## AMENDMENT NO.2

### AIS-023

#### **Automotive Vehicles - Seats, their Anchorages and Head Restraints for Passenger Vehicles of Categories M2, M3 and Goods Vehicles of Category N – Specifications**

**FIG. 3**  
**INDIVIDUAL AND CONTINUOUS PASSENGER SEAT**  
**MINIMUM DIMENSIONS**

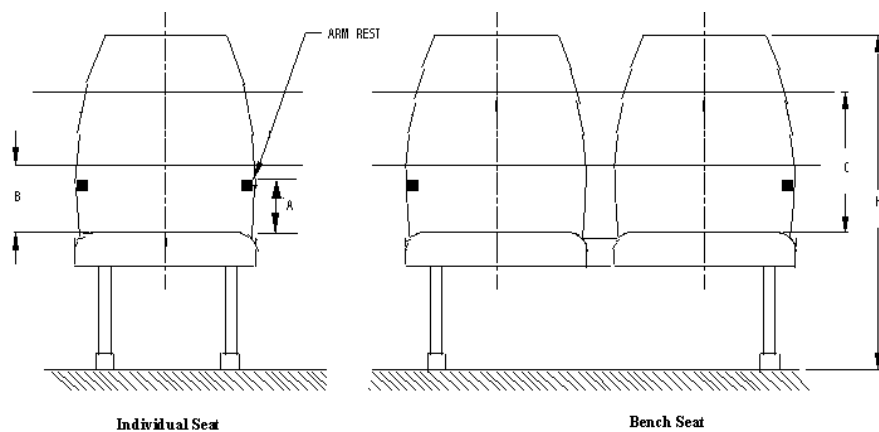
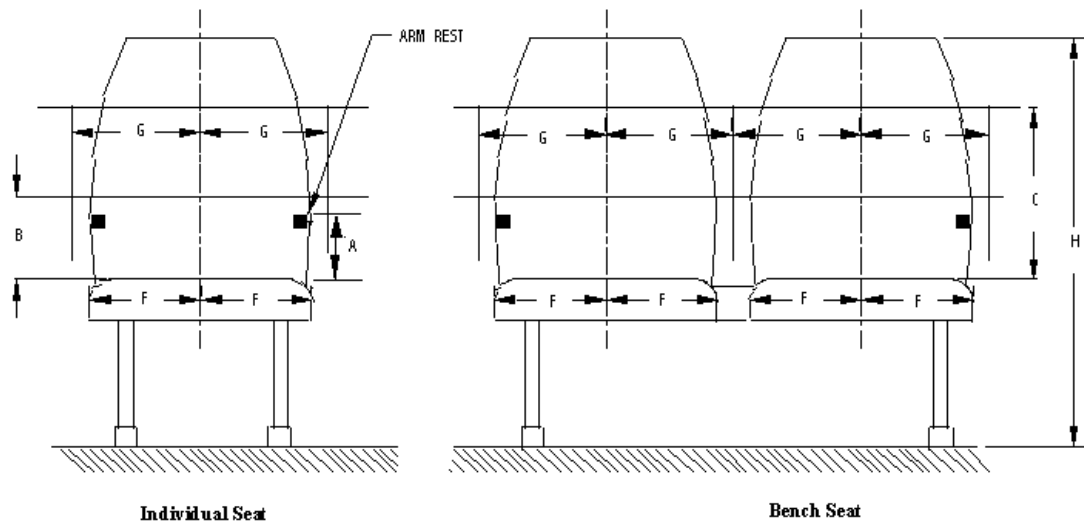
15.0 Page No. 18/29, Figure 3

Substitute following figure for existing figure

(delete reference ‘F’ and ‘G’)

**FIG. 3A**

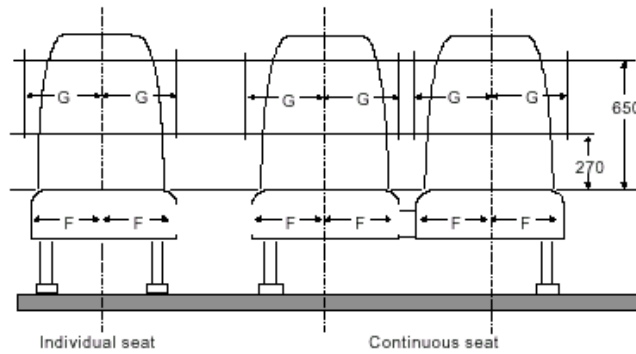
4.3.1.2.1 The minimum width of the available space for each seating position, dimension G (Ref. Fig. 3A), measured from a vertical plane passing through the centre of that seating position at height between 270 mm and 650 mm above the uncompressed seat cushion, shall be not less than:

Individual seats: 250 mm

Continuous rows of seats for two or more passengers : 225 mm.

In case of buses with 3 x 2 layout as defined in AIS 052 : “Code of Practice for Bus Body Design and Approval”, the dimension G referred above shall be 200 mm.

Add following figures 3A, 3B and 3C after existing figure 3

**FIG. 3B**

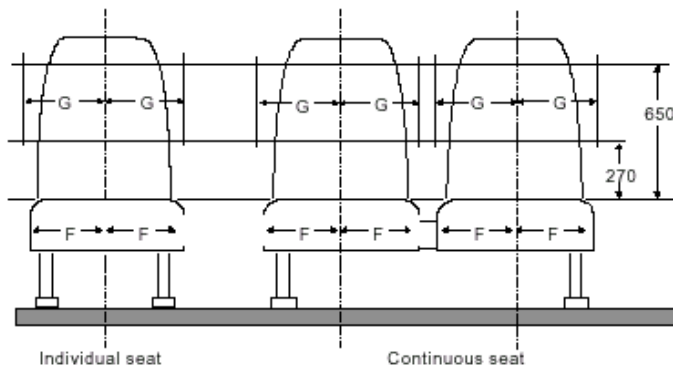
4.3.1.2.2 For vehicles 2.35 m in width or less, the width of the available space for each seating position, measured from a vertical plane passing through the centre of that seating position at heights between 270 mm and 650 mm above the uncompressed seat cushion shall be 200 mm (Ref. Fig. 3B). In case of compliance with this paragraph the requirements of paragraph 4.3.1.2.1. shall not apply.

**FIG. 3C**

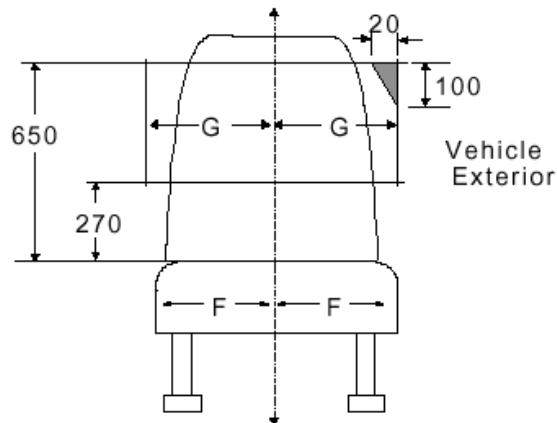
4.3.1.2.3 For vehicles having a capacity not exceeding 22 passengers, in the case of seats adjacent to the wall of the vehicle, the available space does not include, in its upper part, a triangular area 20 mm wide by 100 mm high (Ref. Fig. 3C). In addition, the space needed for safety belts and their anchorages and for the sun visor should be considered as exempted.

- G = 225 mm if continuous seat
- G = 250 mm if individual seat
- G = 200 mm for vehicles less than 2.35 m wide

**FIG. 7A**

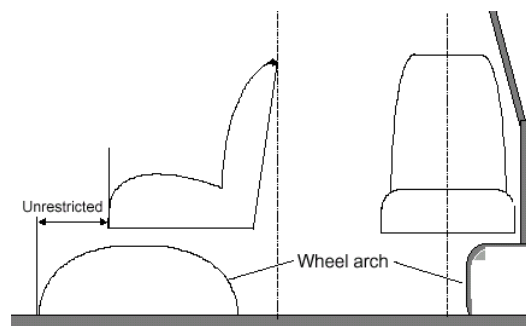
4.3.1.10.1.1. the intrusion does not extend beyond the median vertical plane of the seating position (Ref. Fig. 7A), or

18.0 Page No. 22/29, Figure 7  
Add following figures 7A and 7B after existing figure 7

**FIG. 7B**  
**PERMITTED INTRUSION OF A WHEEL ARCH**  
**EXTENDING BEYOND THE VERTICAL CENTRE LINE OF**  
**THE SIDE SEAT**  
(see annex 3, paragraph 4.3.1.10.1.2)

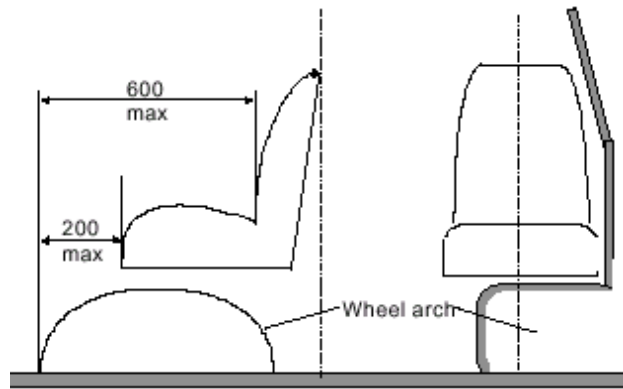
4.3.1.10.1.2. the nearest edge of the area 300 mm in depth available for the feet of the seated passenger is advanced no more than 200 mm from the edge of the uncompressed seat cushion and to not more than 600 mm in front of the squab of the seat, these measurements being made in the median vertical plane of the seating position (Ref. Fig. 7B). In the case of two seats facing each other this provision shall apply to only one of the seats and the remaining space for the feet of seated passengers must be at least 400 mm.”

**FIG. 4**

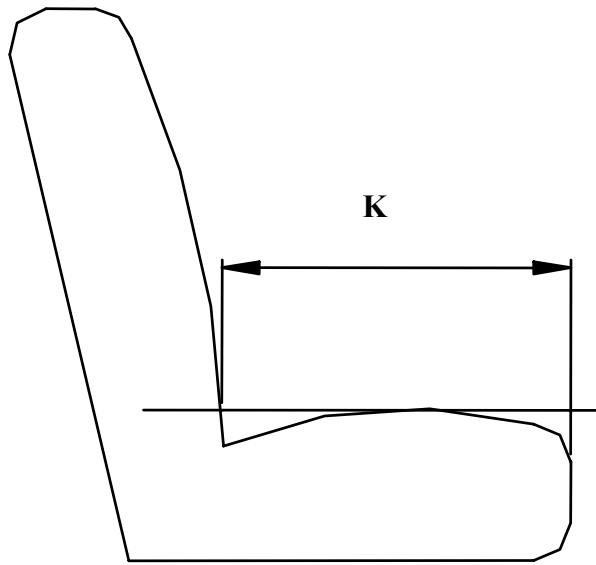
“4.3.1.4 The minimum depth of the uncompressed seat cushion (K), measured along the longitudinal plane passing through the centre of that seating position (Ref. Fig.4) :

M2 and Class I	: 350 mm
Class II	: 400 mm
Class III	: 400 mm”

FIG. 5

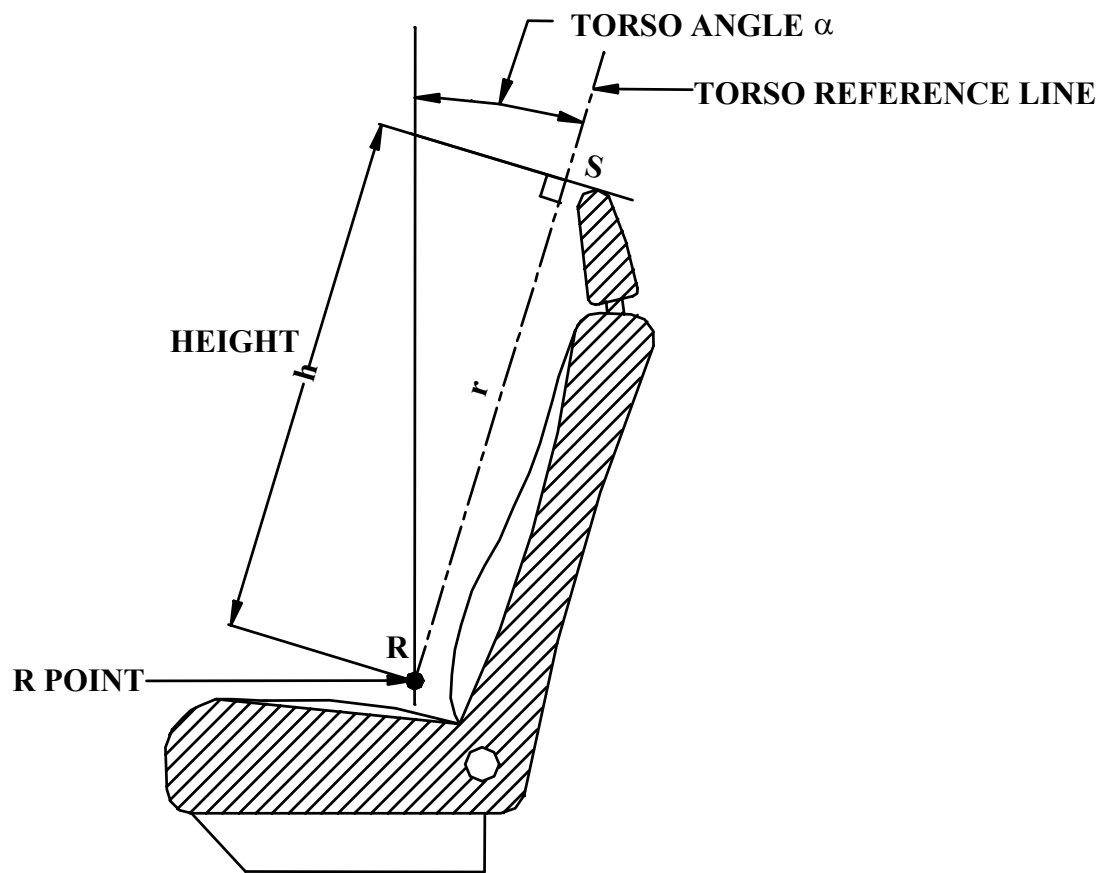
4.3.1.5 Minimum torso angle ( $\alpha$  °)(Ref. Fig.5) :

M2 and Class I	: 12°
Class II	: 15°
Class III	: 15°

**FIG. 6**  
**MINIMUM PITCH BETWEEN**  
**THE TWO ADJACENT ROWS OF THE SEAT**

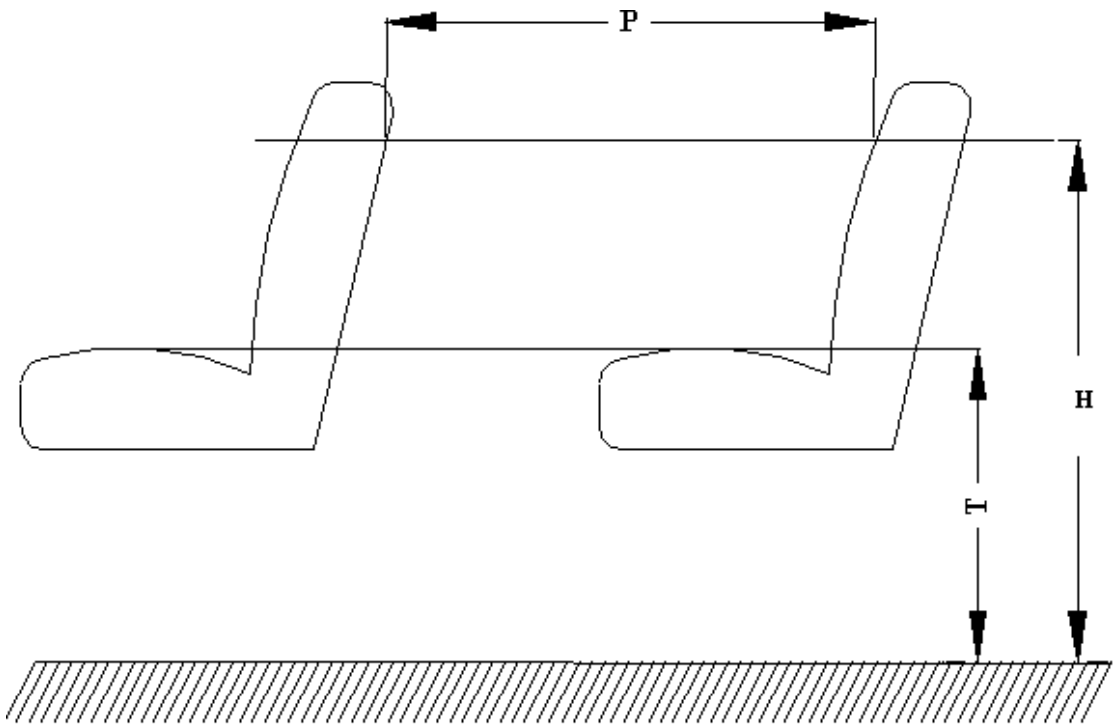
17.0 Page No. 21/29, Figure 6, Title  
Substitute following Title for existing Title

**Minimum Spacing between the Two Adjacent Rows of the Seat**

FIG. 7

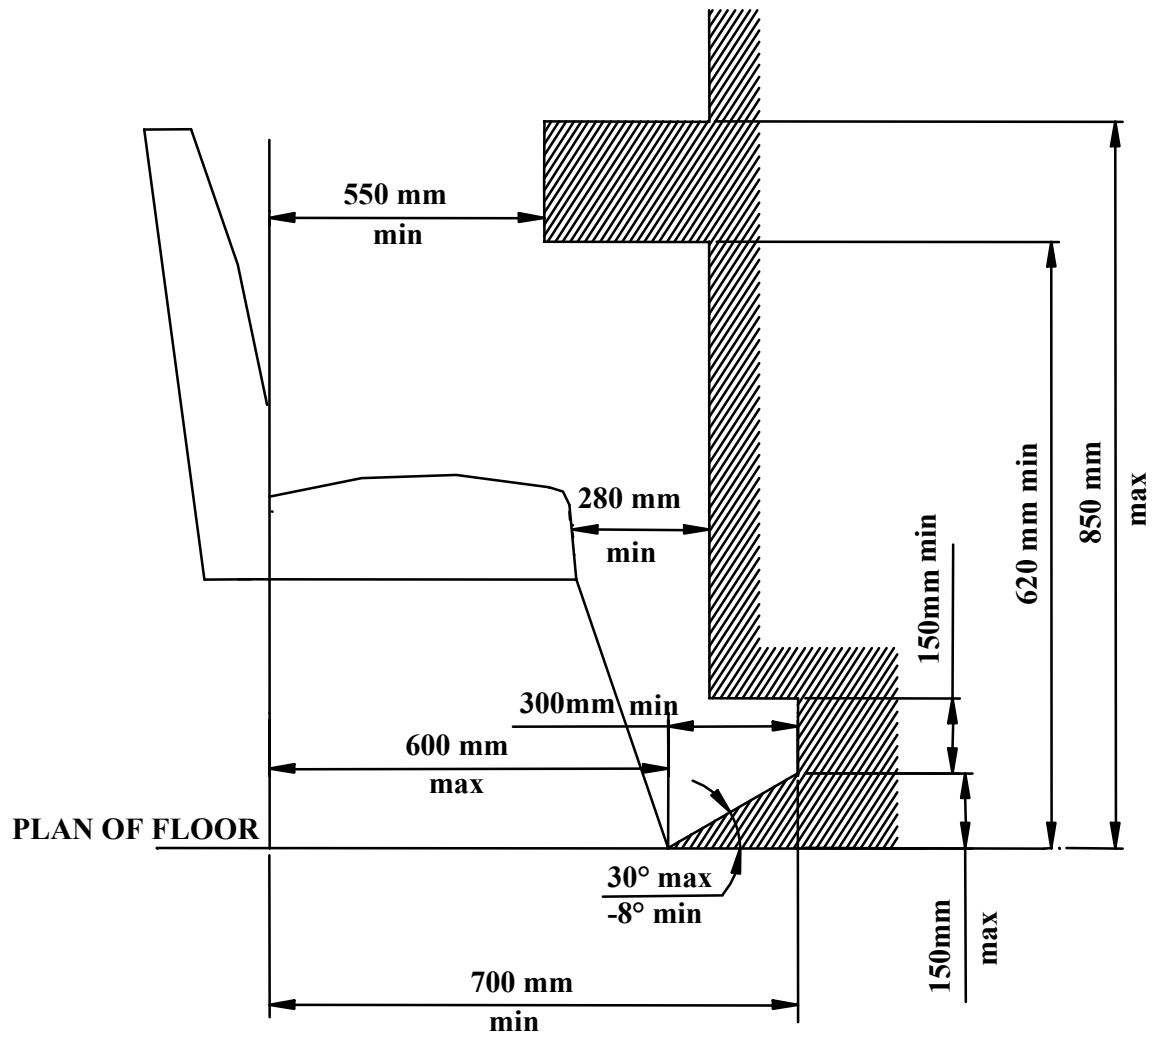
For a seat behind a partition or other rigid structure other than a seat, a minimum clear space in front of each required passenger seating space (as defined in paragraph 4.3.1.10) shall be provided as shown in figure 7. A partition whose contour corresponds approximately to that of the inclined seat back may intrude into this space. In the case of seats alongside the driver's seat in vehicles with up to 22 passengers, intrusion of the

FIG. 8

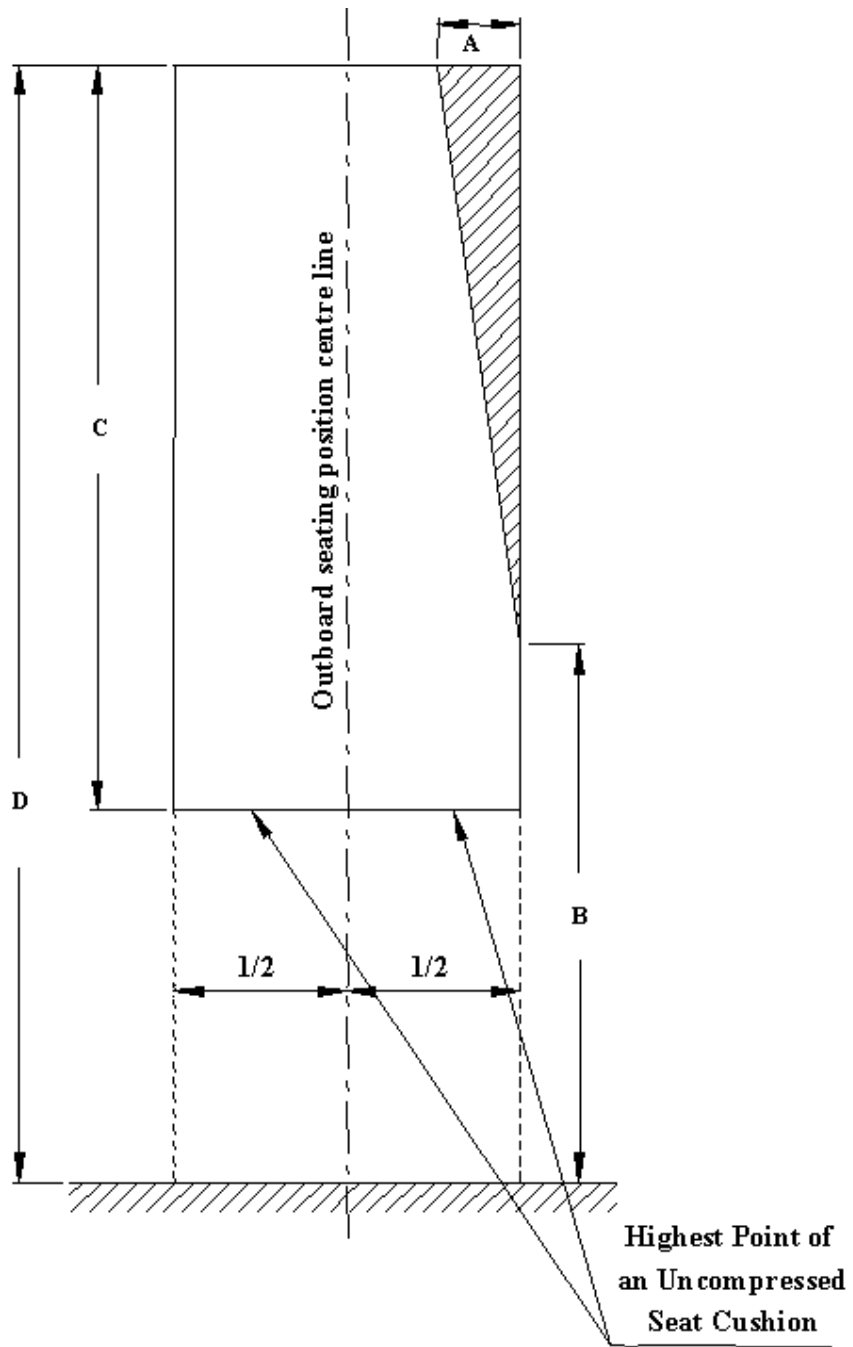
4.5.1.5.2 In the space -----peak is situated 650 mm (B in Fig. 8) from the floor and whose base is 100 mm (A in Fig. 8) in width-----transmission tunnel etc.
